# STAFF RECOMMENDATION

NCPC File No. 6762

**NEBRASKA AVENUE COMPLEX  
CAMPUS SECURITY UPGRADES**  
Nebraska Avenue, NW at Massachusetts Avenue, NW  
Washington, D.C.

September 27, 2007

Proposed Fence Line Layout

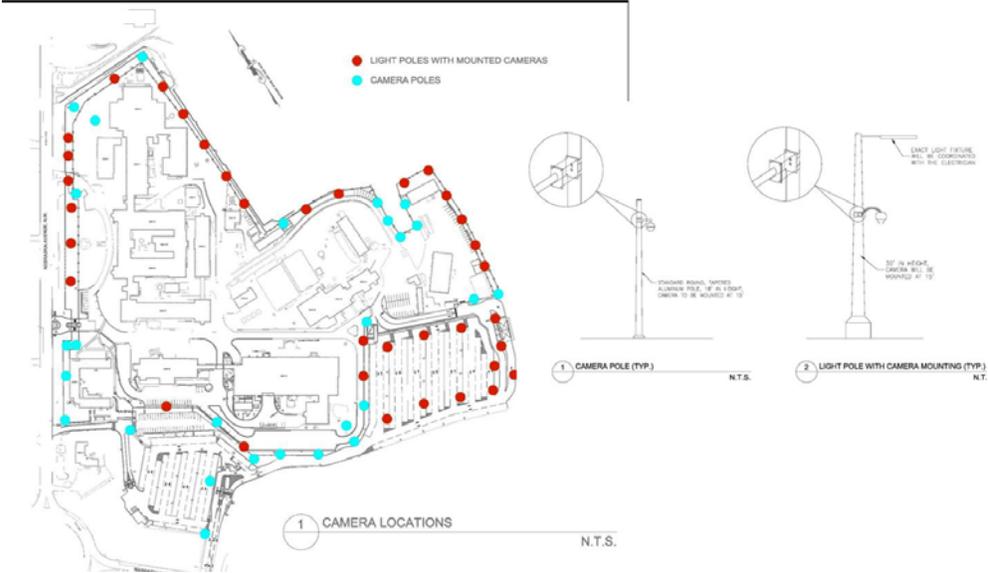
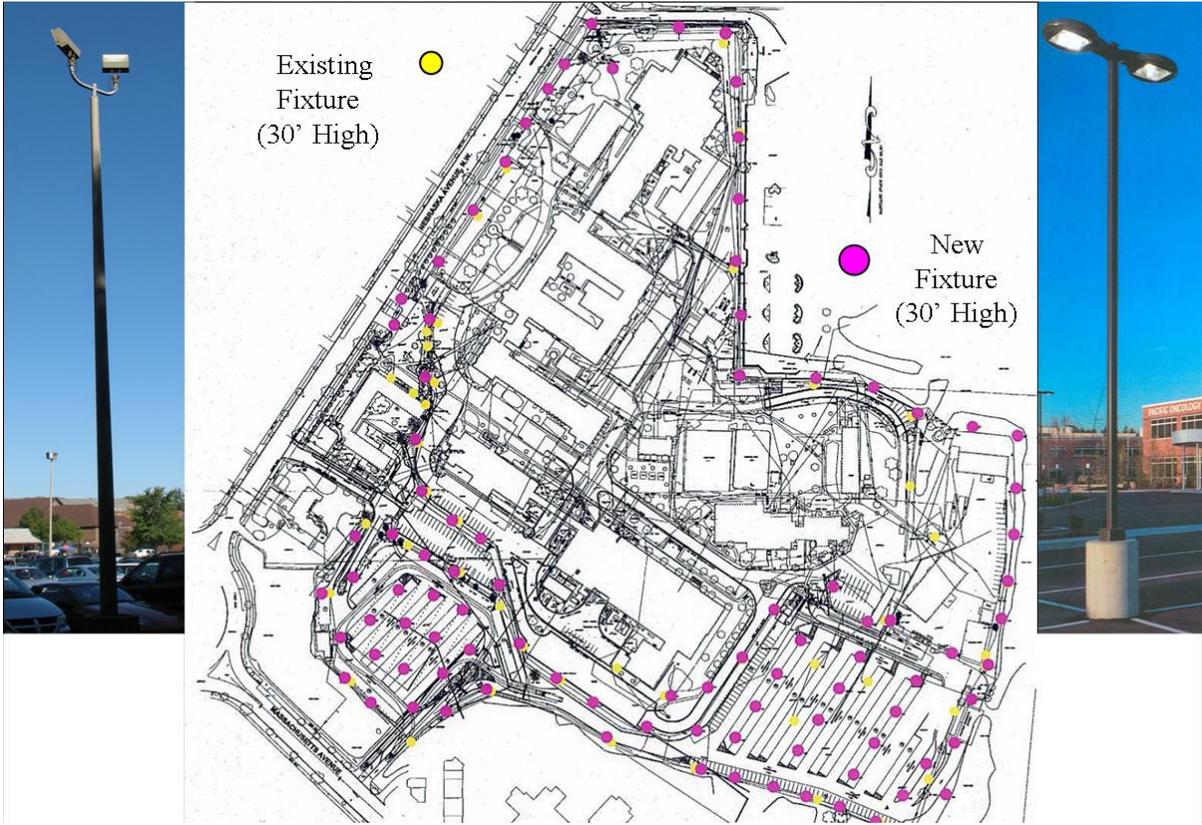
Staff supports the continuation and extension of the decorative fencing along Nebraska Avenue to unify the appearance along Nebraska Avenue. Staff commends the applicant for converting

from chain link to decorative fencing at other personnel entrance points, as recommended in consultation. Staff further supports the use of more industrial types of fencing at the back of the NAC, as well as the use of no-climb mini-mesh fencing where there will be no visual observation of the fence line by guards. Staff understands and notes that all perimeter fencing will occur inside the property line, and not in public space.

Proposed Nebraska Avenue Entrance (North)

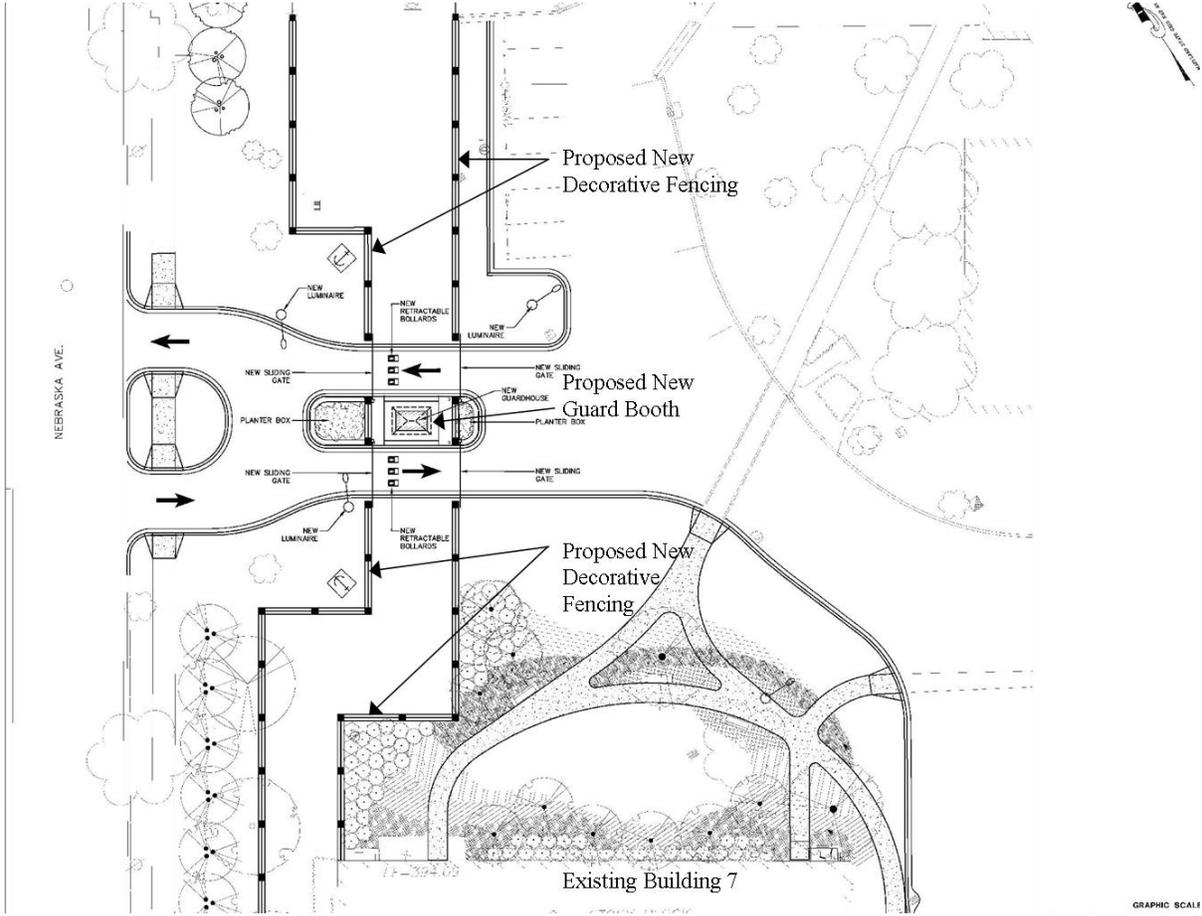
The applicant has indicated that the project will improve the circulation at entrances and throughout the campus. Streamlining both vehicle and pedestrian circulation (roads, sidewalks and plazas), and earmarking various entry points for use by various types of users will improve its legibility. The main (north) entrance on Nebraska will no longer be cluttered by various users or by unclear circulation such as shuttle buses that must turn around. A new traffic island will streamline one-way traffic on either side. In addition, its users will be streamlined to VIPs and emergency vehicles only. Staff supports the conversion of miscellaneous parking lots, as well as Building 11 to be demolished, into green space and plaza, which will also increase the buffer space between double fence lines. Staff further supports the drive-through routing of shuttle buses, entering on Nebraska and proceeding to exit directly onto Massachusetts Avenue without requiring turn-around space.

Proposed Guard Booth Locations Flanking Parking Lot

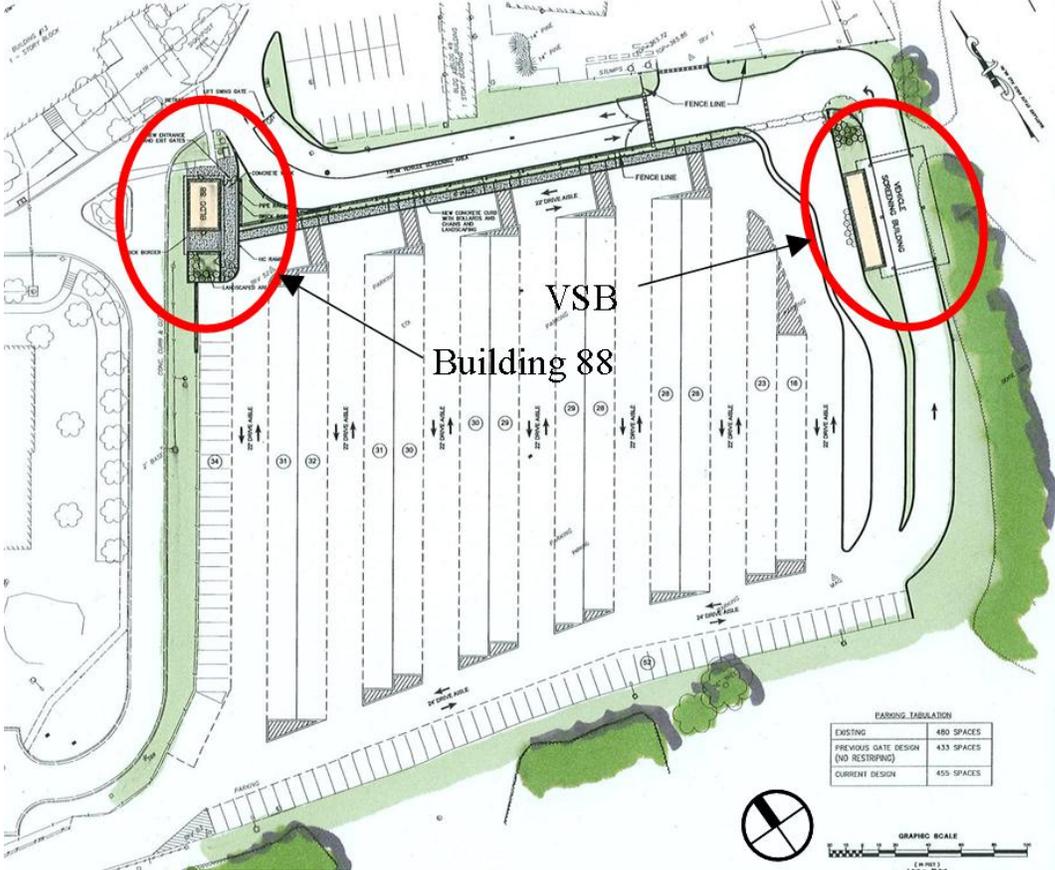
The guard booth elevations that are included in the submittal show facade materials that are compatible with the existing architecture on the campus, and have made effective use of planters in front of the guard booths. Although the low planting in them is not delineated, staff supports the use of as much additional planting around the guard booths as possible to soften these areas.

Day vs. Night Time Lighting Simulation Looking East along the South, East Perimeter

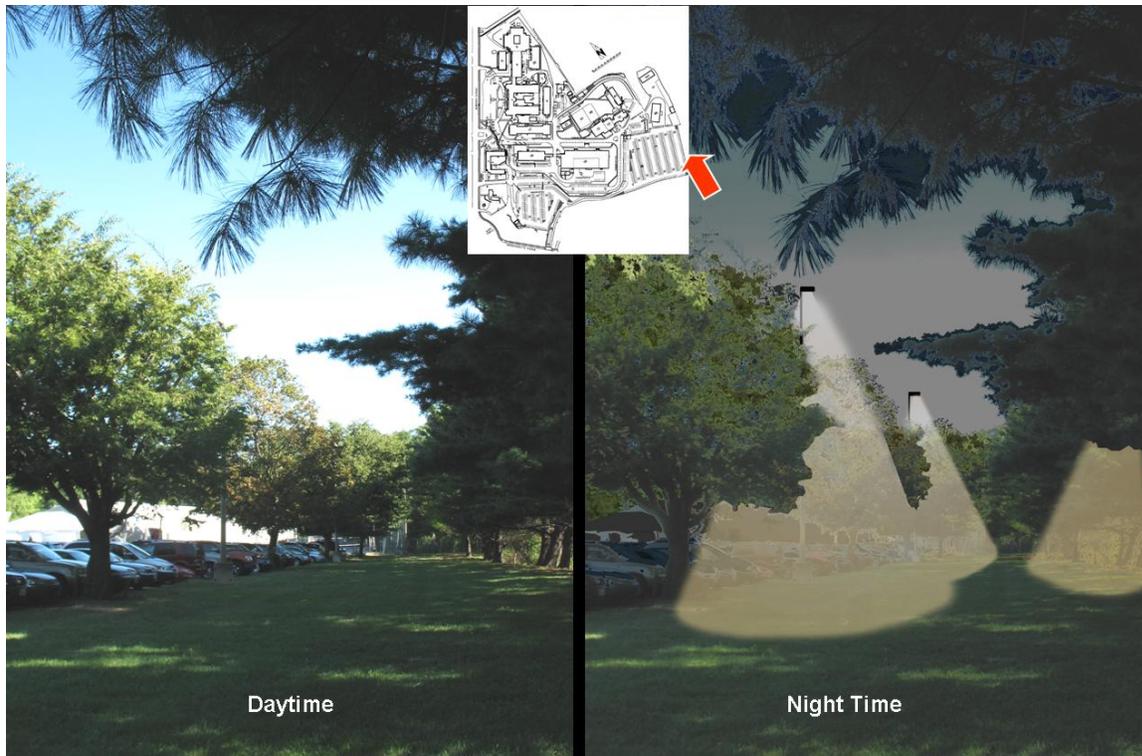
In response to the Commission’s request at concept submittal to submit visual simulations or renderings to demonstrate any lighting spill-over beyond the property line, the applicant has submitted an elevation to simulate lighting conditions at night at the VSB. It demonstrates the improved directional lighting that will be provided to replace existing flood lighting. Even though lighting is not entirely contained on the underside of the canopy, the fixtures’ downward direction is much improved from the existing flood lighting conditions that the applicant encountered. The following images further demonstrate how the applicant’s lighting scheme at the campus perimeter will improve upon the existing by directing the light rather than flooding.
